UN Regulation No. 131

Uniform provisions concerning the approval of motor vehicles with regard to the Advanced Emergency Braking System (AEBS) for M₂, M₃, N₂ and N₃ vehicles

Industry comments and proposals for AEBS-HDV-08

Figure 1:
Left turn or right turn at the intersection

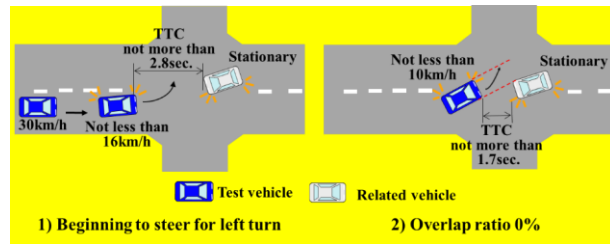
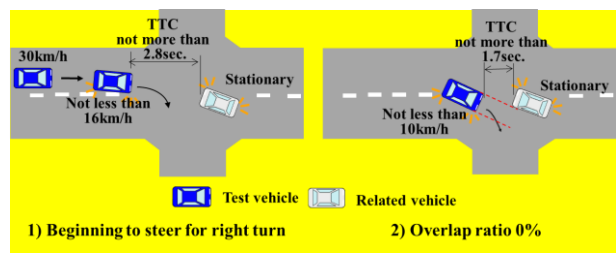
Commenté [TP26]: This scenario is not relevant for the heaviest vehicle categories (see slide 4 of document AEBS-HDV-07-14-r1).
